TOWN OF SOUTHWEST RANCHES, FLORIDA
Dykes Road Drainage and Water Quality Project
IFB No. 17-007
Wednesday, August 30, 2017

ADDENDUM 3

SECTION F-F

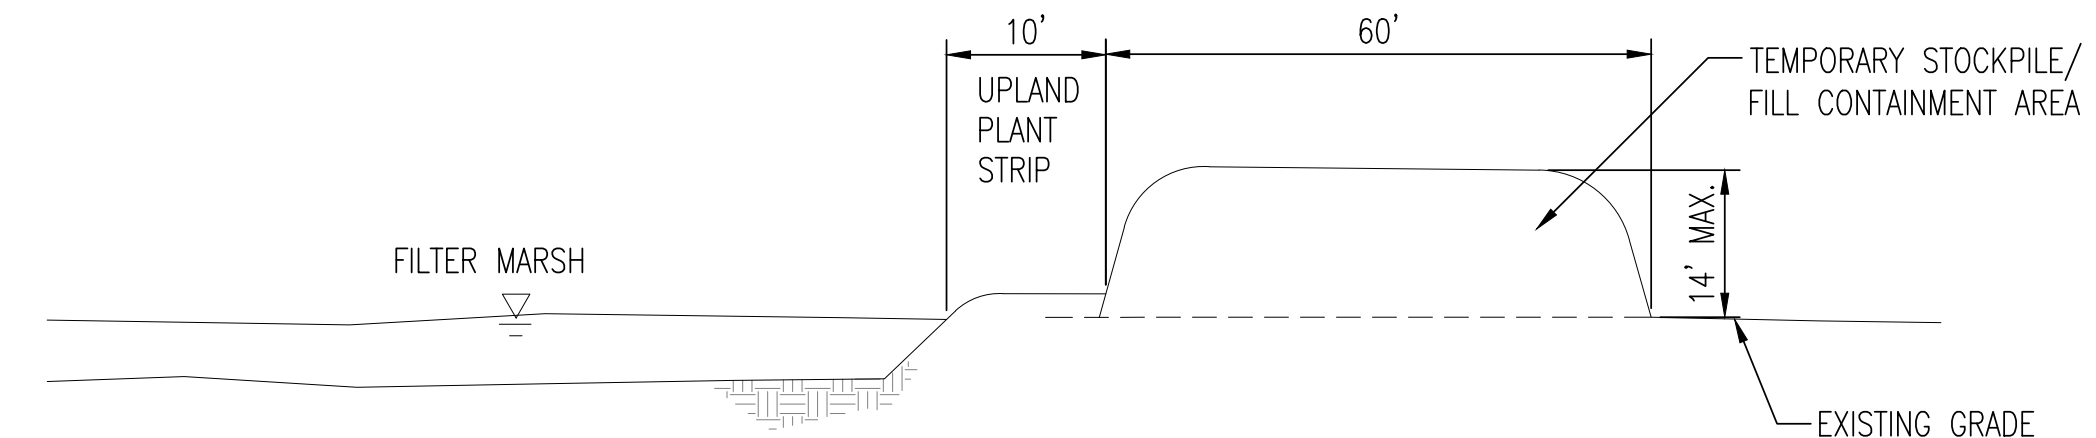
- Changed all elevations on the engineering plans from NGVD 29 to NAVD 88.
- The elevations on the survey (which is part of the plan set) have not been changed and remain at NGVD 29.
- Added Sheet 10 – Disposal and Containment Plan. Contractor is still responsible to remove all surplus material off of the site.
- Added sections F-F and G-G to Sheet 5 of 10.
